Transmission Expansion Advisory Committee PPL Supplemental Project (S1106 Project Scope Change)

March 10, 2020

S1106 Project Scope Change

Existing Solution:

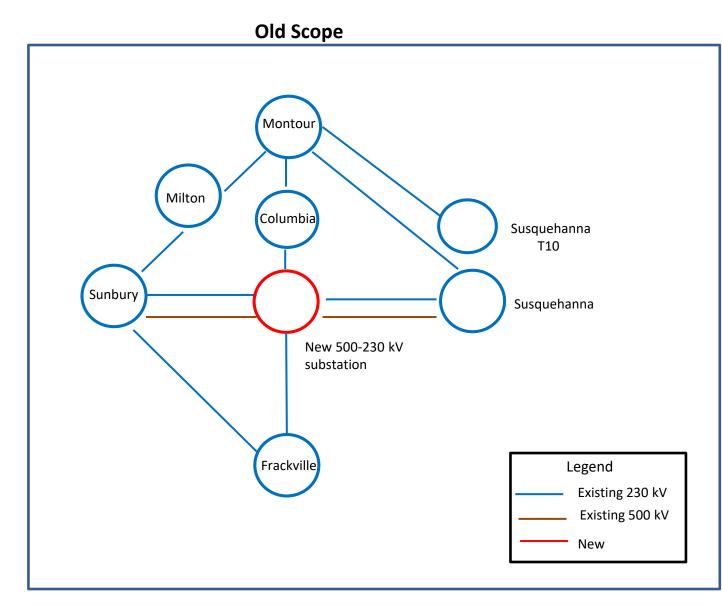
Build a new 500-230 kV substation and associated transmission work by tapping Sunbury-Susquehanna 500 and 230 kV lines and Columbia-Frackville 230 kV line.

Updated Potential Solution:

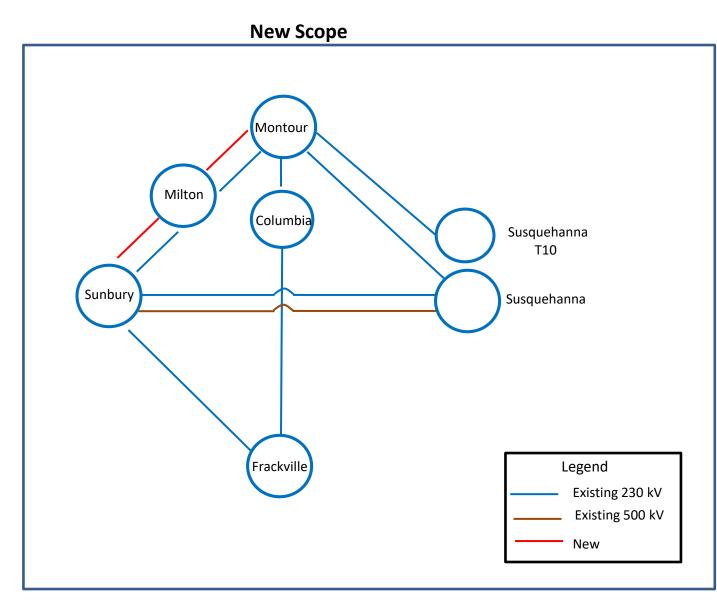
- Establish ~22 miles of second circuit on existing 230 kV lines between Montour, Milton and Sunbury substations.
 - Rebuild ~12 miles of Montour-Milton 230 kV line to double circuit.
 - Change the operating voltage of ~10 miles of 69 kV line between MILT and SUNB 230 kV substations.
- Perform line terminal work at Montour, Milton and Sunbury 230 kV substations to terminate the new circuit.
